SUBMITTAL REVIEW COMMENTS

PROJECT Paragon Star
PROJECT NO 185004412
DATE 8/23/2022
SUBMITTAL Sports Lighting Foundations
SUBMITTAL NO 265668
REVIEWER John Plackemeier
HENDERSON NO E005

PARAGON
SOCCER FIELDS
FIELD LIGHTING
LEE'S SUMMIT, MO

DRAWING TITLE:
POLE AND FOUNDATION

POLE FOUNDATION ELEVATION

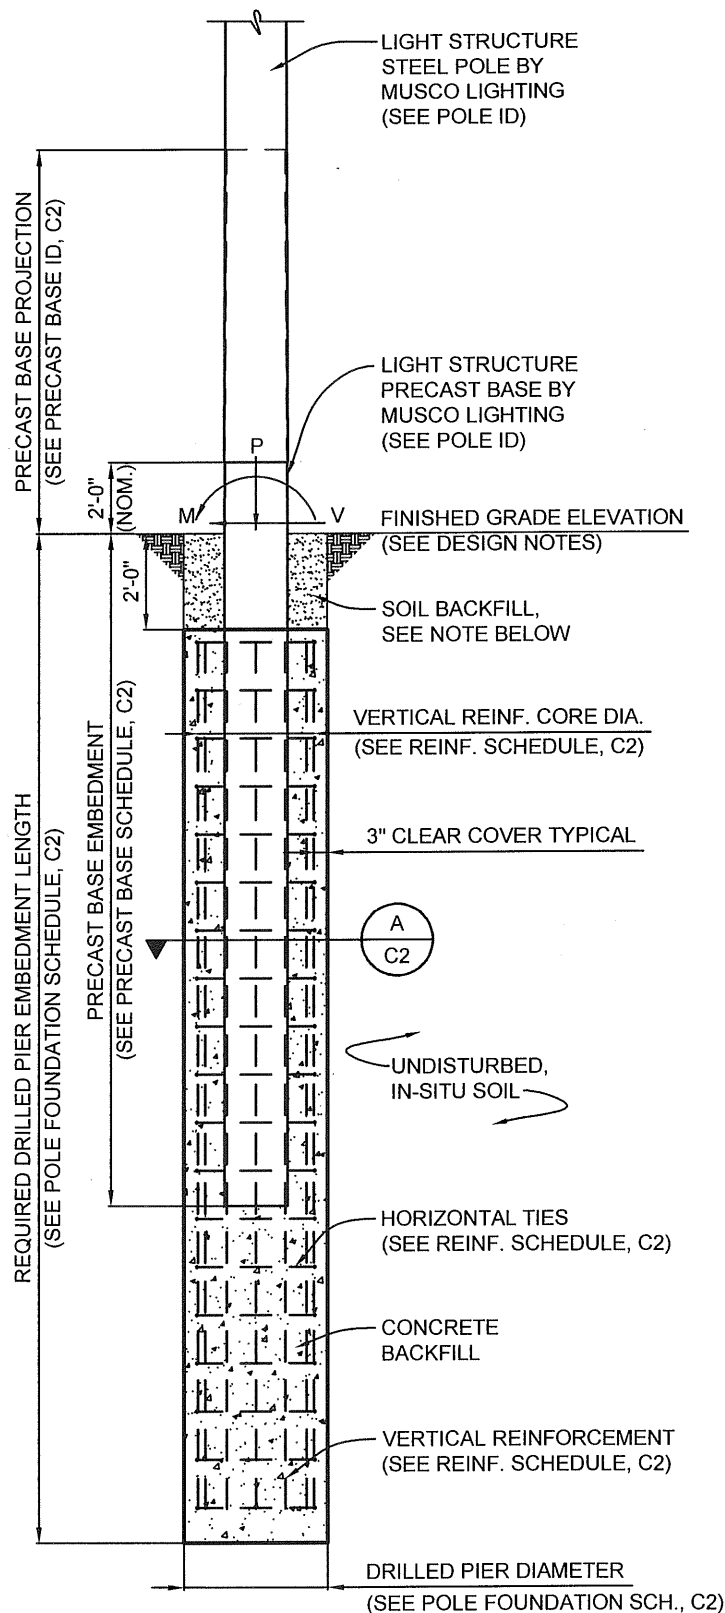
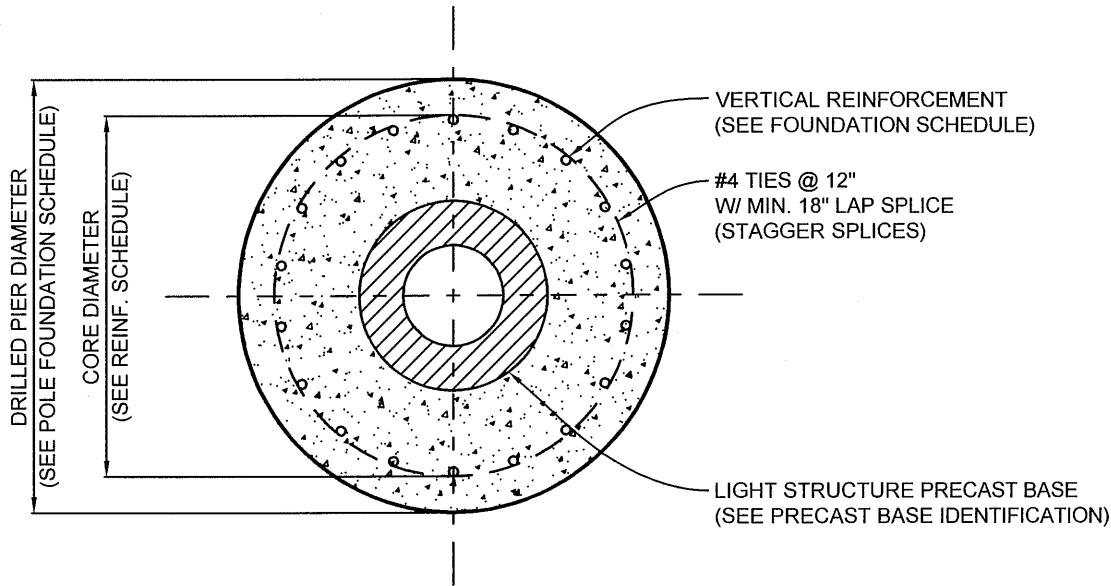
COMMENT #	ACTION CODE	DESCRIPTION	COMMENTS
1	2	Foundations	No exceptions taken. Sub-contractors shall coordinate exact location for footings/foundations with civil engineer and general contractor. Field coordinate with sports field surface vendor/supplies and other trades prior to digging/boring. Installer shall maintain all required clearances of easements and other disciplines per local codes.
